M-9A0 (Calpella + N11P/M Discrete Graphic)

FOXCONN		HON HAI Precision Ind. Co., Ltd.	
Title		CCPBG - R&D Division	
Size		Document Number	
Custom		M9A0 MP	
Date:		Wednesday, October 28, 2009	Sheet 5 of 73
		Rev 1.1

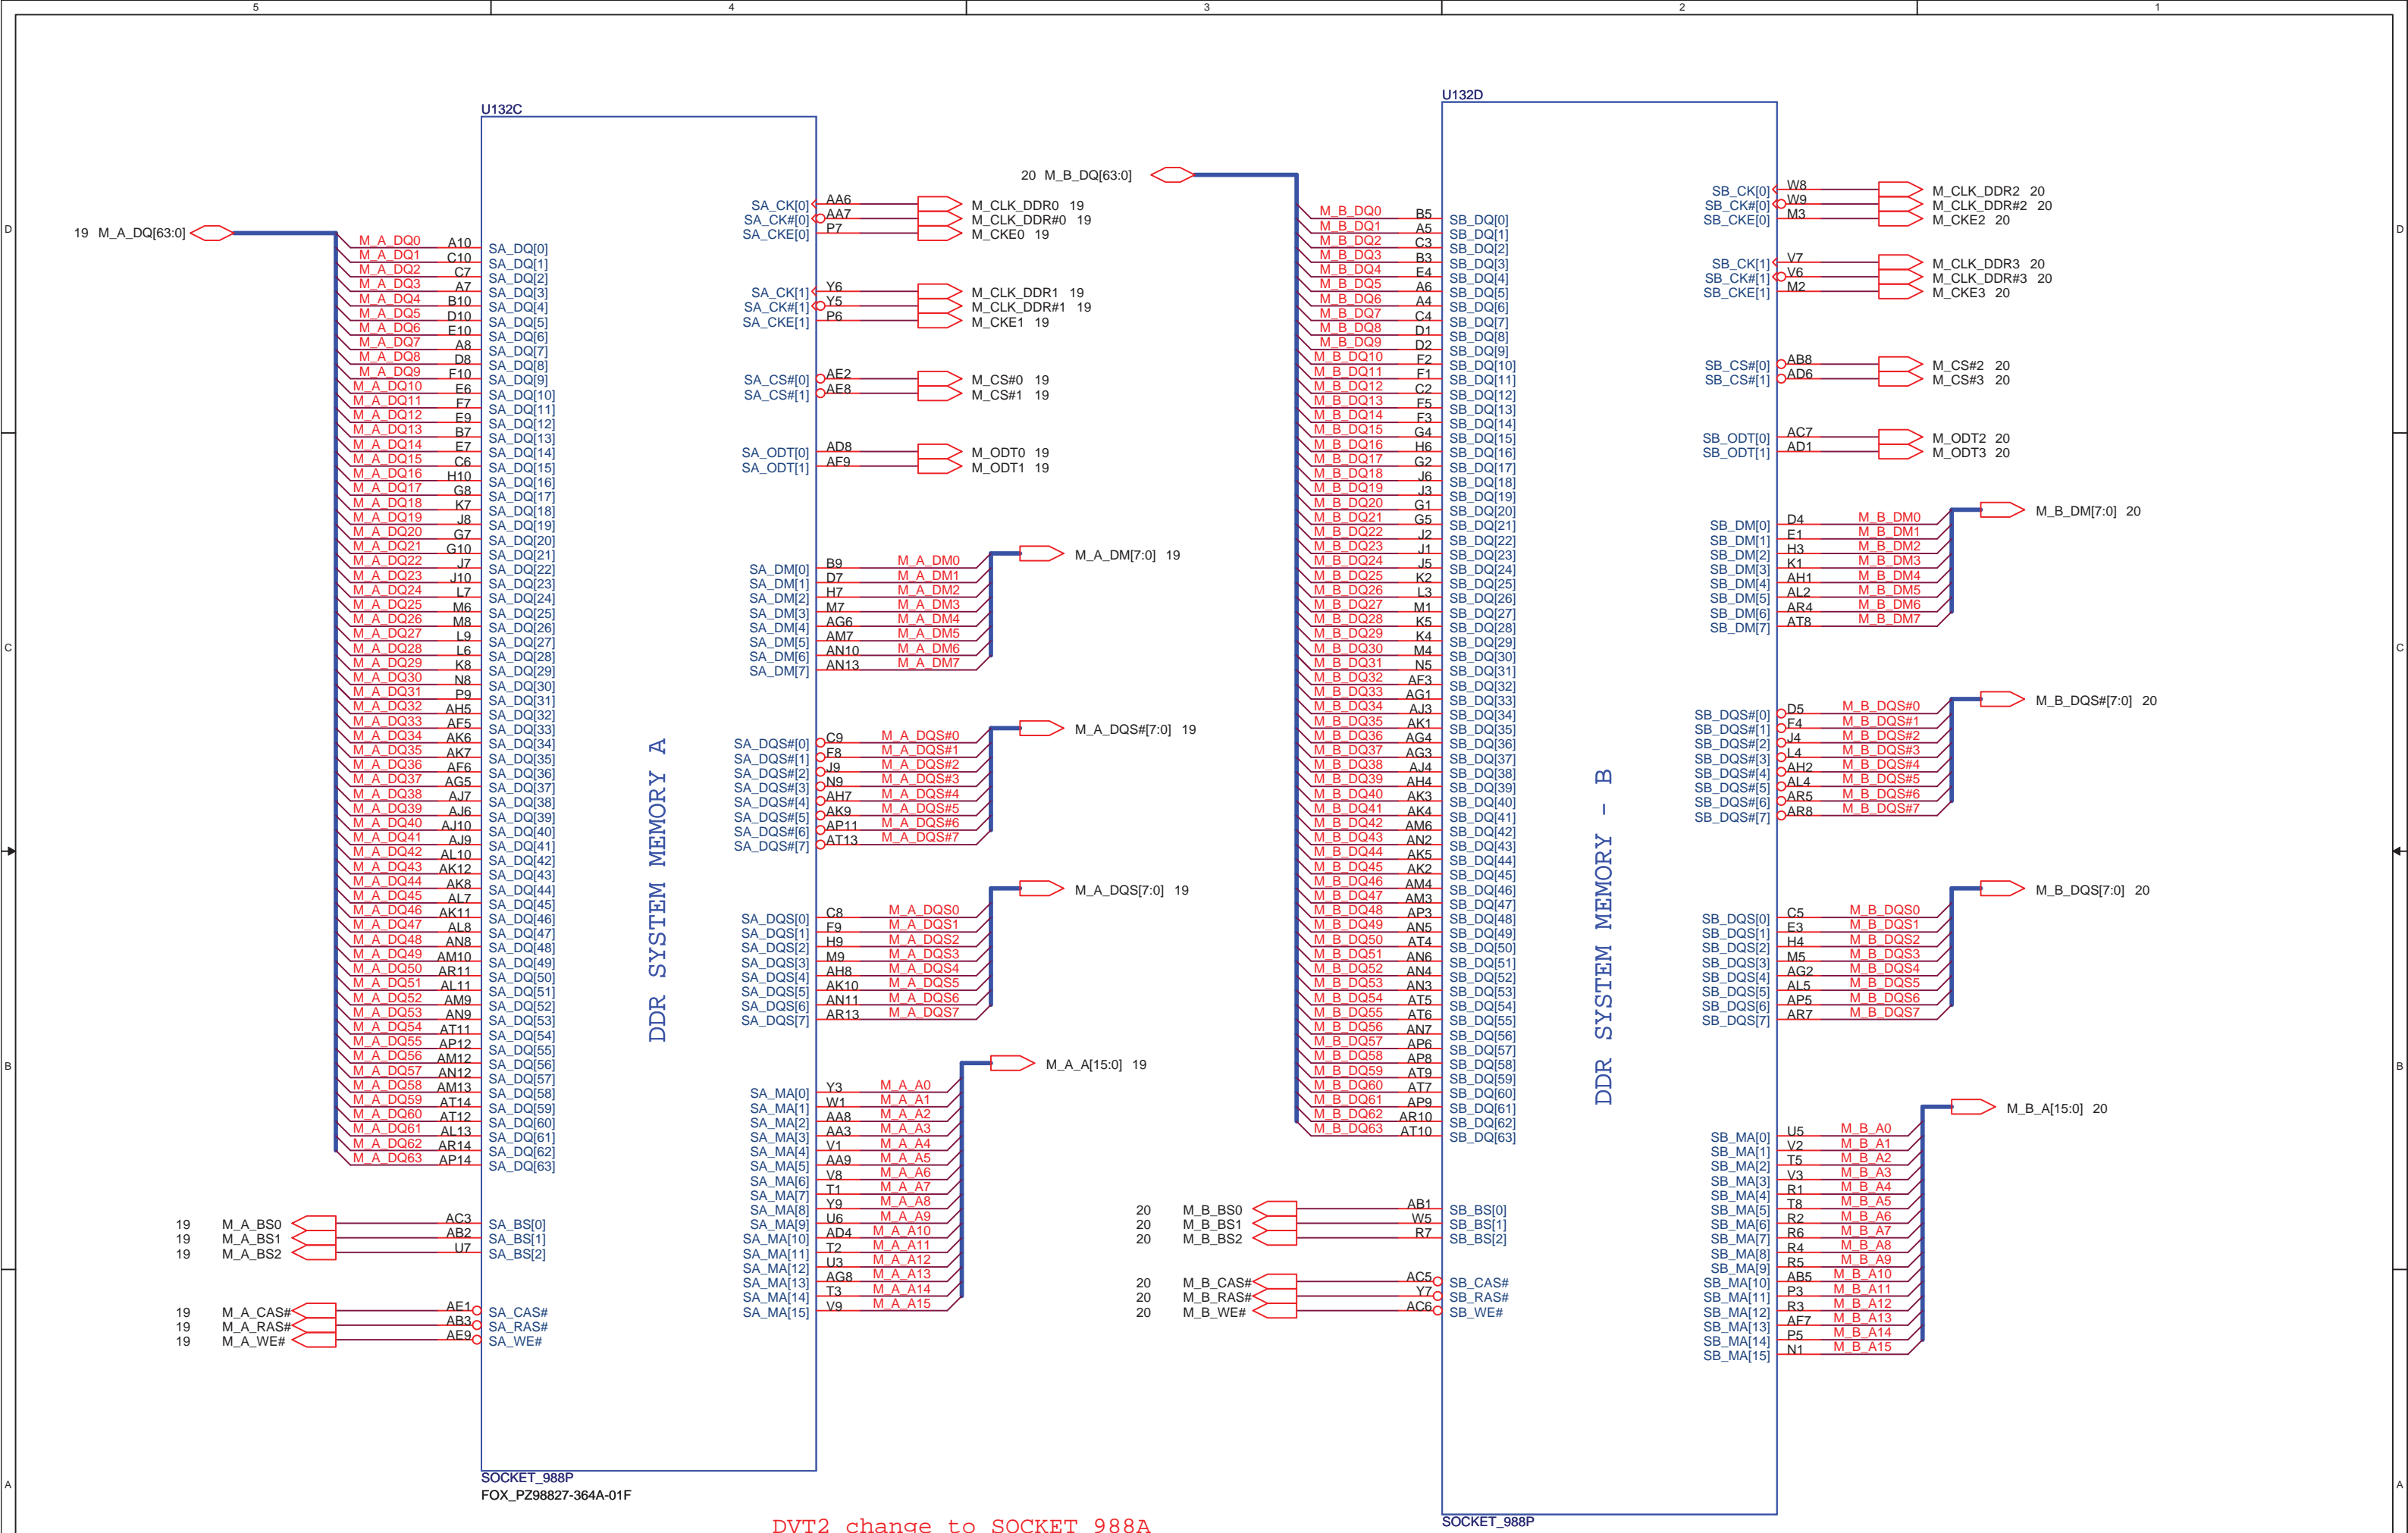
2009/09/10
Change C6131 from NC to 0.047U for DVT2

DVT2 change to SOCKET_988A

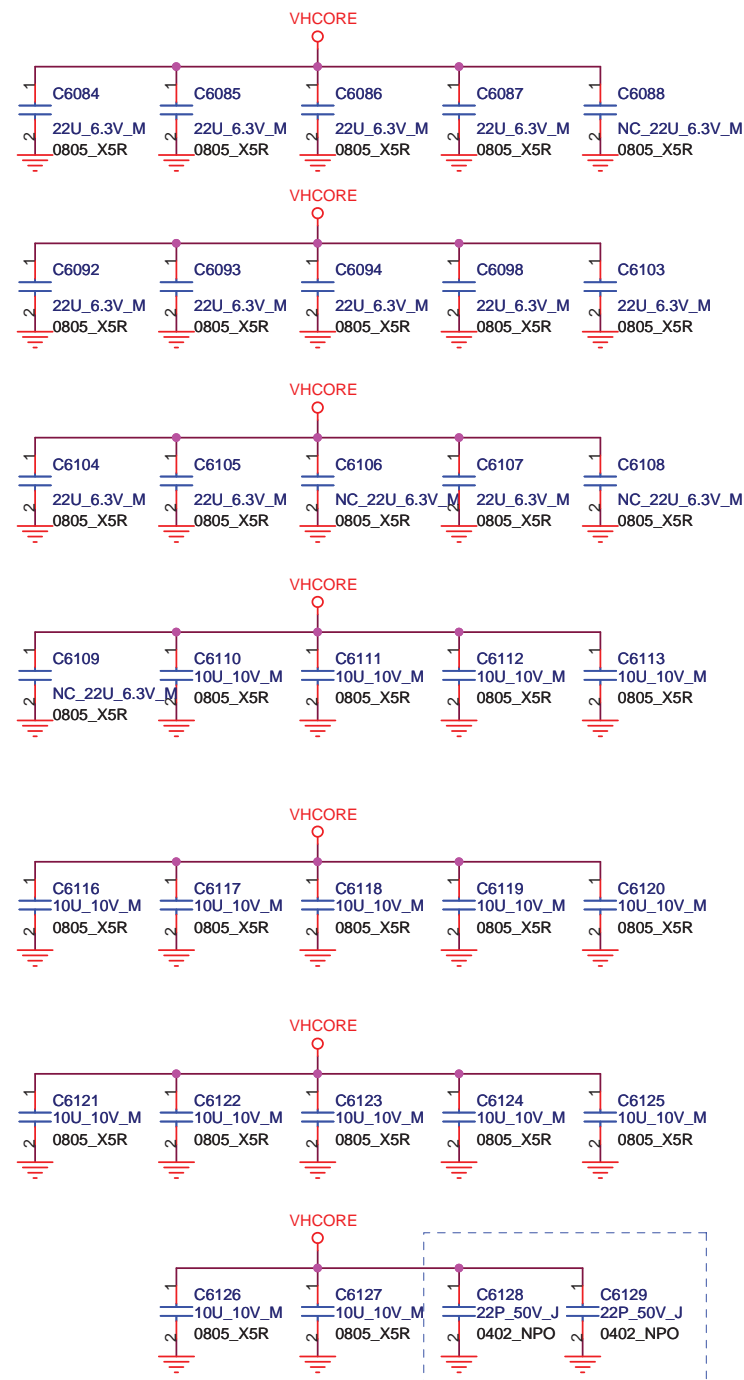
Delete R5785 0ohm resistor for voltage drop problem

Delete R5786 for PVT

DVT2 change to SOCKET_988A

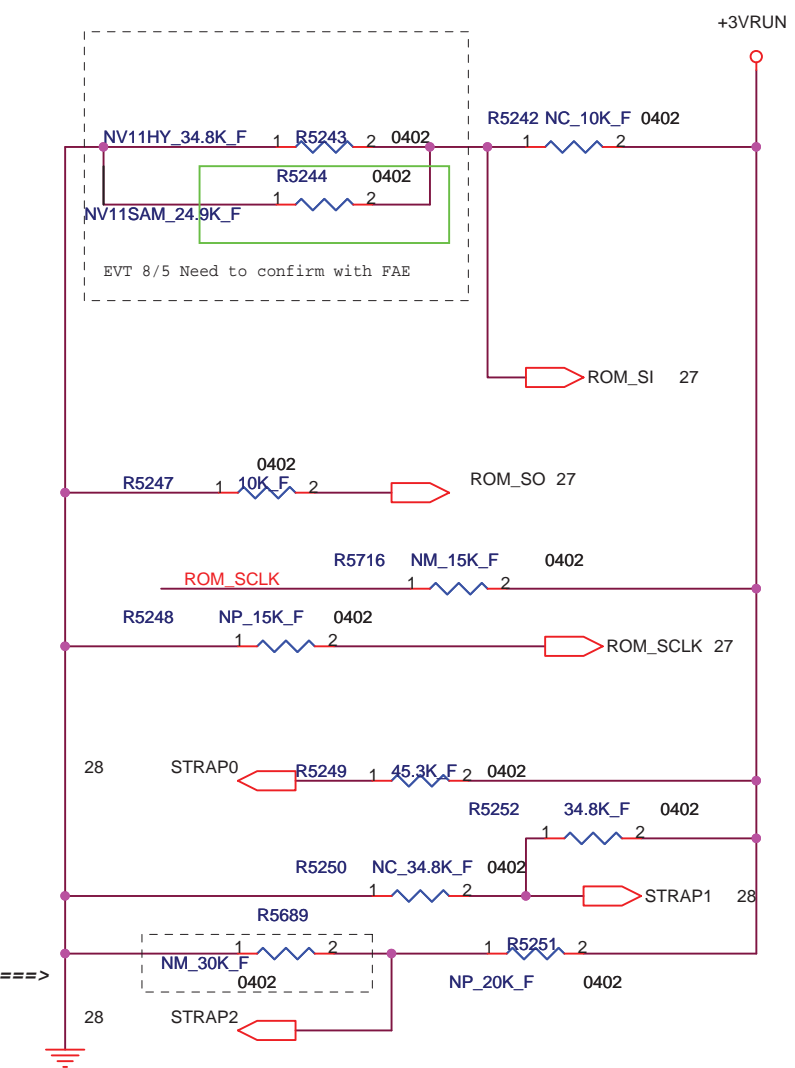
2009/9/10
N11P-LP1+SANSUNG(H2) SKU and N11M-GE1 +SANSUANG(M2 SKU)need change BOM
R5244 change from 1R-0004532-F200(45.3K) to 1R-0002492-F200(24.9K) for nVIDIA FAE suggest

FOXCONN HON HAI PRECISION IND. CO., LTD.		
CPBG - R&D Division		
Title	VRAM(GDDR)# 1/2	
Size	Document Number	Rev
Custom	M9A0_MP	1.1
Date:	Thursday, November 19, 2009	Sheet 30 of 73

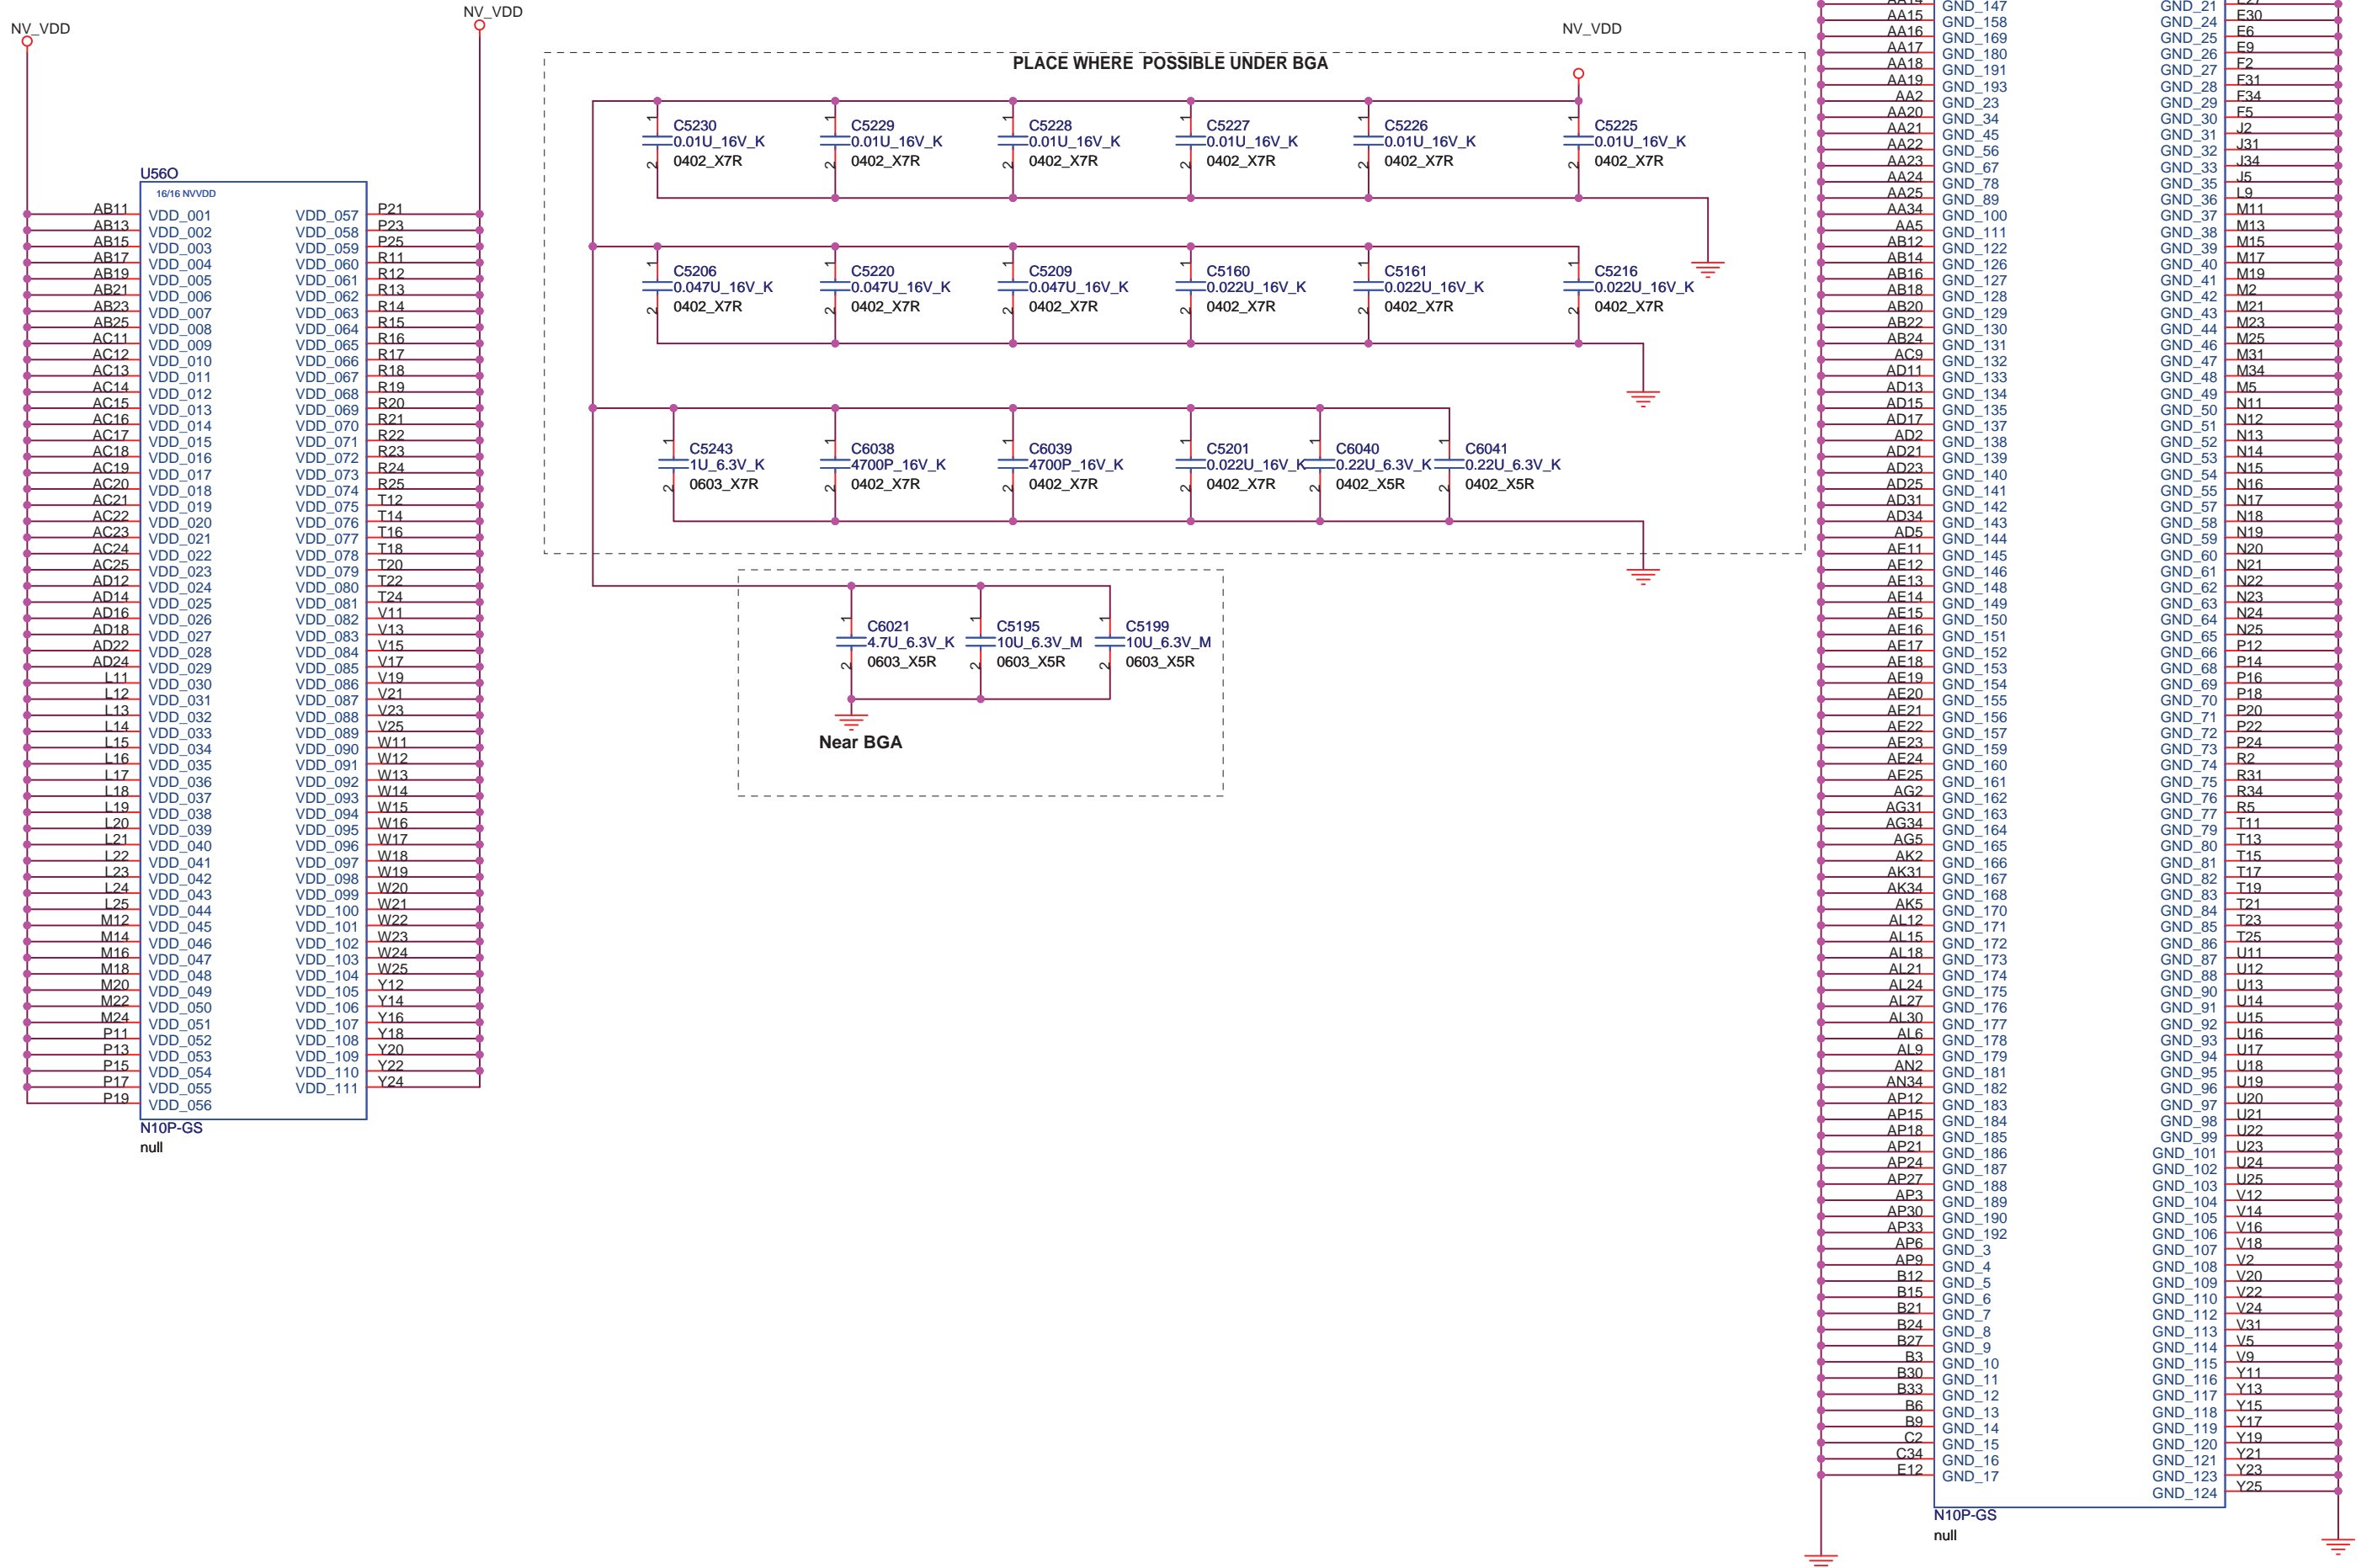
2009/9/10
N11P-LP1+SAMSUNG(H2 SKU)
Change R5340,R5341,R5342,R5343 from
1R-0001331-F200(1.33K) to 1R-0000222-J200(2.2K)
for nVIDIA FAE suggest.

2009/9/10
N11P-LP1+SAMSUNG(H2 SKU)
Change R5331,R5332,R5333,R5334 from
1R-0005490-F200(549ohm) to 1R-0009310-F200(931ohm)
for nVIDIA FAE suggest.

2009/9/10
N11P-LP1+SANSUNG(H2 SKU)
Change R5335,R5337,R5338,R5339 from
1R-0009310-F200(931ohm) to 1R-0000122-F200(1.2K)
for nVIDIA FAE suggest.
